City of Lakewood
Board of Zoning Appeals

MINUTES
BOARD OF ZONING APPEALS
REVIEW MEETING
LAKEWOOD CITY HALL
MARCH 19, 2026
6:30 P.M.
RECORDING AVAILABLE

4. Docket No. 03-04-26 1020 Parkside Dr.

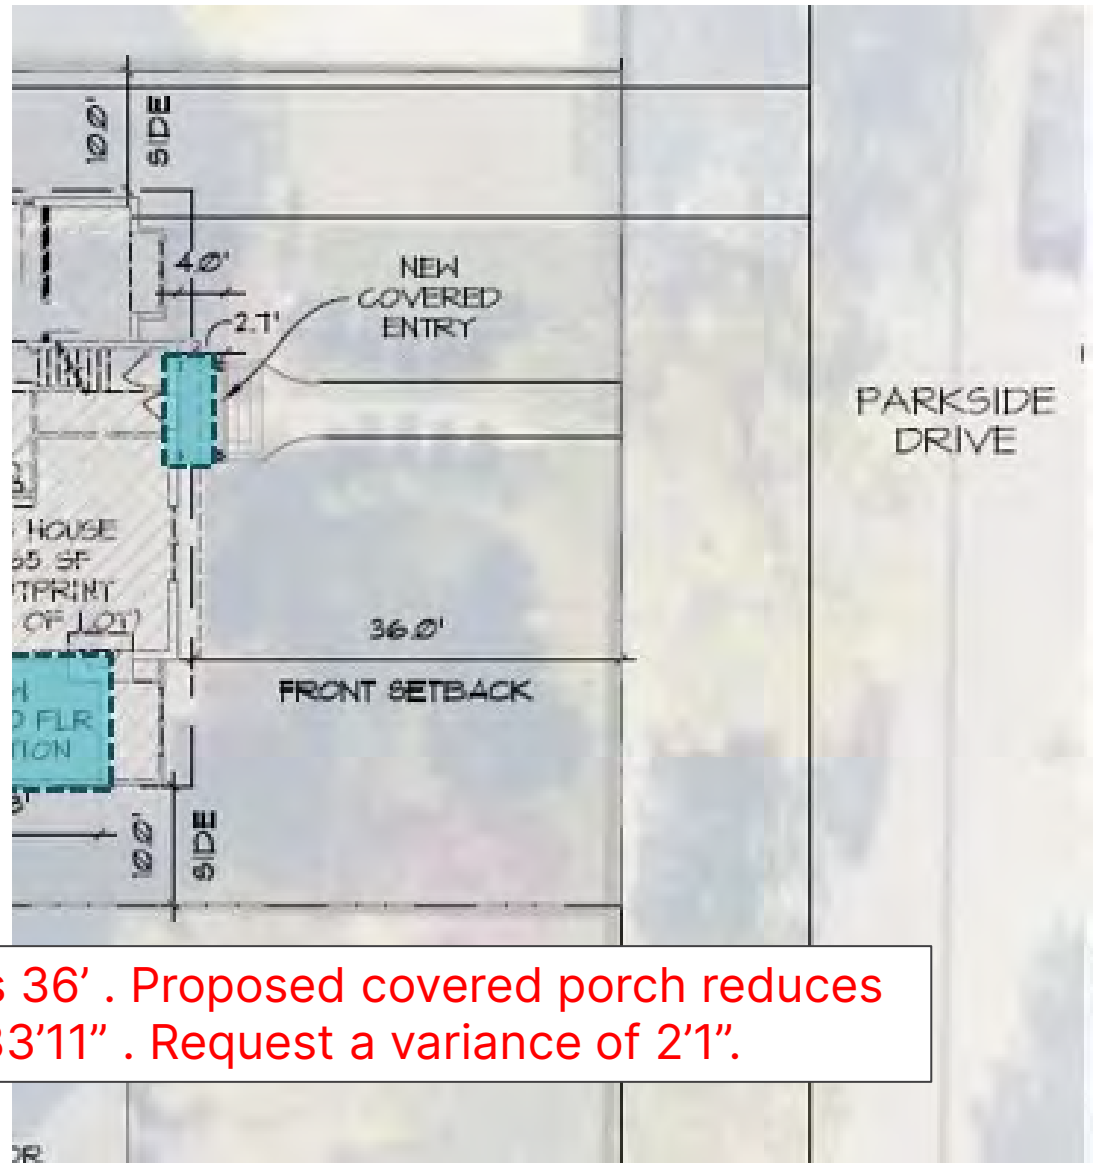
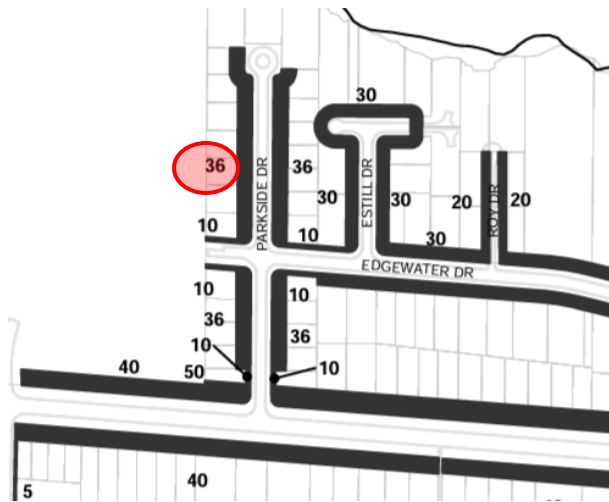
8'6" + (18'6"/2) = 16'8" calculated midpoint height
Maximum permitted is 15', request variance to exceed by 1' 8"

Required front setback is 36'. Proposed covered porch reduces front setback by 2'1" to 33'11". Request a variance of 2'1".

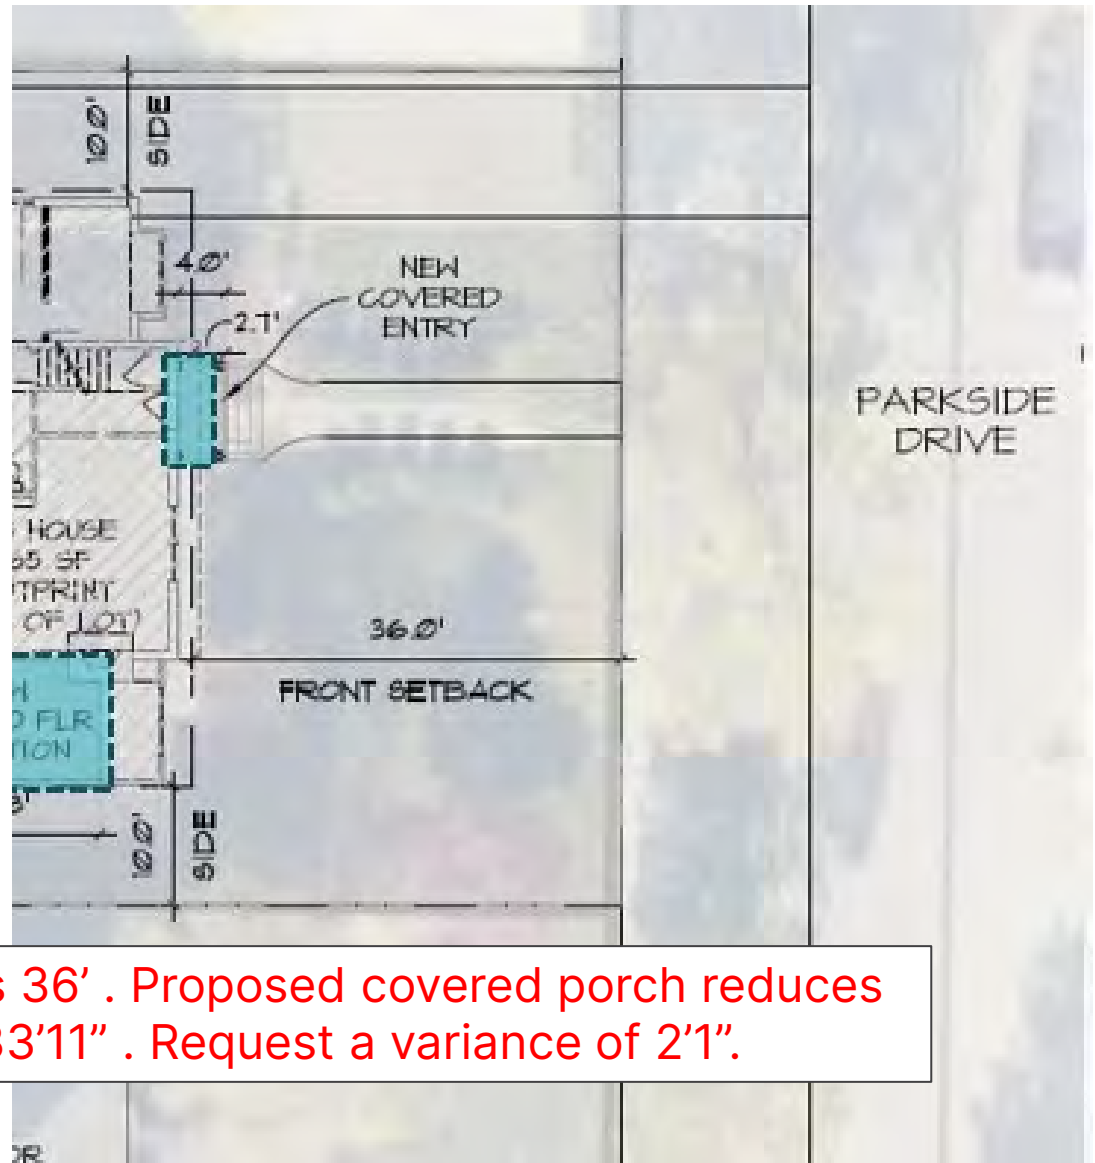
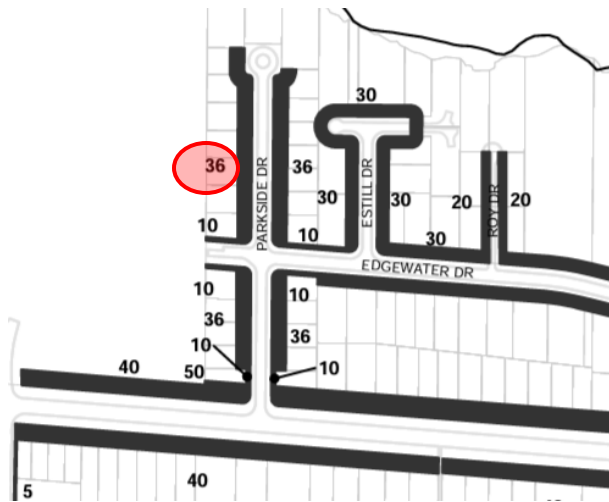
Required front setback is 36'. Proposed covered porch reduces front setback by 2'1" to 33'11". Request a variance of 2'1".

8'6" + (18'6"/2) = 16'8" calculated midpoint height
Maximum permitted is 15', request variance to exceed by 1' 8"

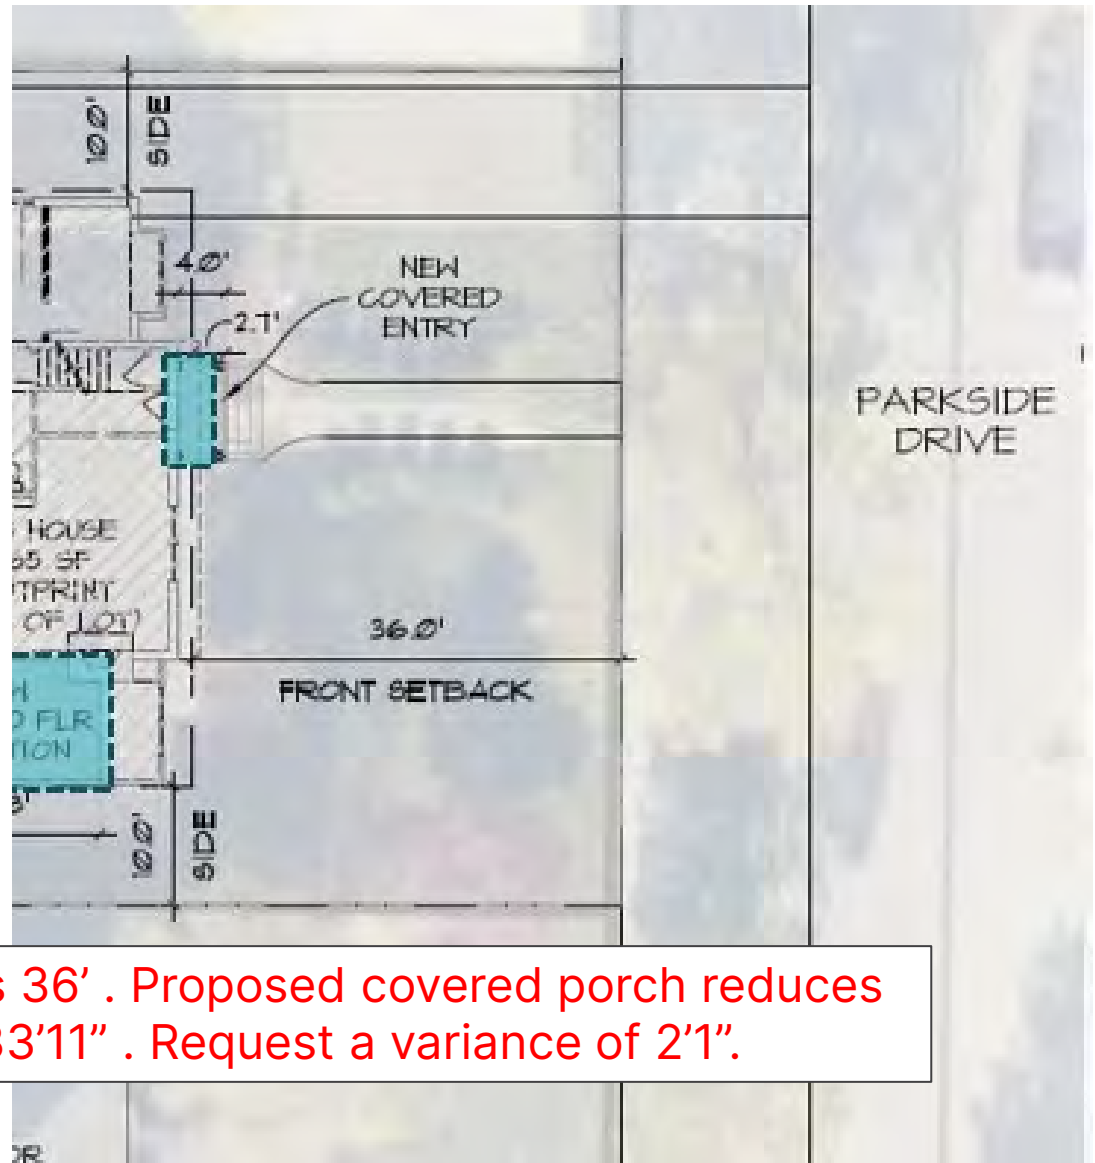
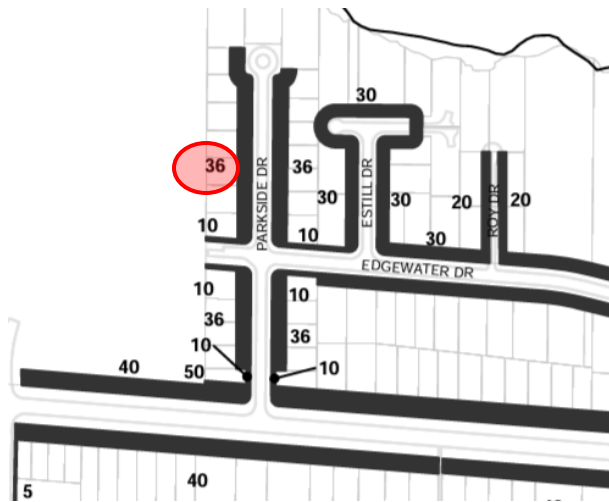
8'6" + (18'6"/2) = 16'8" calculated midpoint height
Maximum permitted is 15', request variance to exceed by 1' 8"

Required front setback is 36'. Proposed covered porch reduces front setback by 2'1" to 33'11". Request a variance of 2'1".
